# LEHIGH INDUSTRIAL PARK Inactive Hazardous Waste Site

Lackawanna (C), Erie County, New York  
Site No. 9-15-145

## RECORD OF DECISION

**RESPONSIVENESS SUMMARY**  
for the  
**PROPOSED REMEDIAL ACTION PLAN**

Figure 5

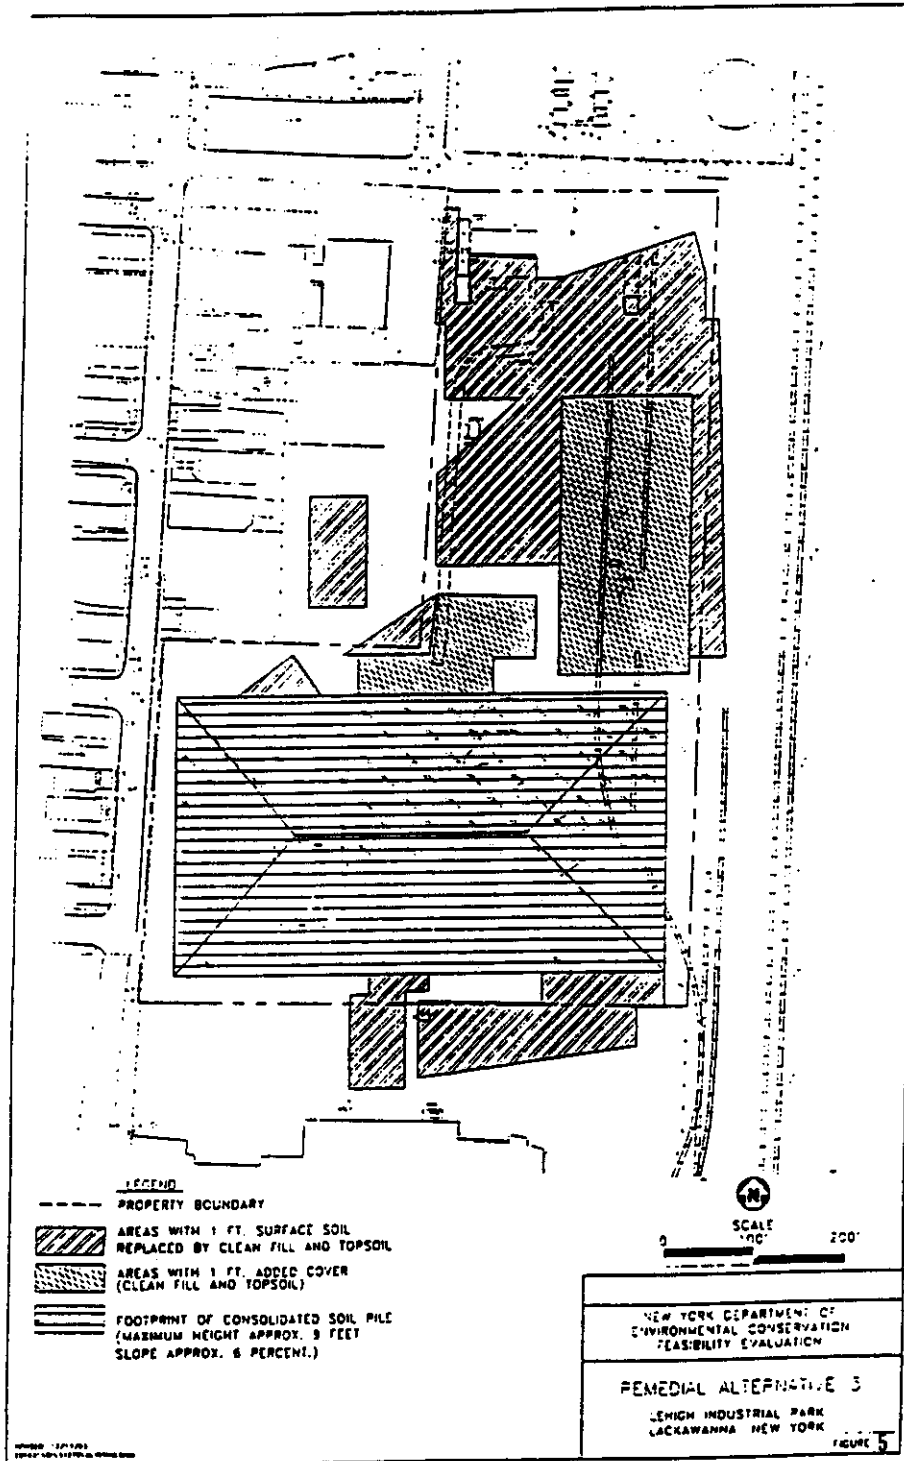
**COMMENT #3:** In the capped area, what will the height be above the current ground surface?

**COMMENT #15:** The area which will be capped will be a nine foot tall mound. How can you make a baseball or a soccer field or anything out of it if it will be shaped like a pyramid? Are capping it and the nine foot tall mound two different options?

**RESPONSE #3:** In the conceptual plan presented as Figure 5 of the ROD, the proposed configuration would result in a mounded area of about four acres with a maximum height of about nine (9) feet above the existing ground surface. However, as noted at the meeting, flexibility in designing this capped area exists which could result in a lower capped height but possibly over a larger area, dependent on any beneficial reuse which may ultimately be considered for the site.

**RESPONSE #15:** Whether the final shape is a pyramid or a recreational field, the site will be capped. The mound shape proposed as a conceptual plan for the cap is one option, other configurations are possible provided they can achieve the design specifications of the cap itself.
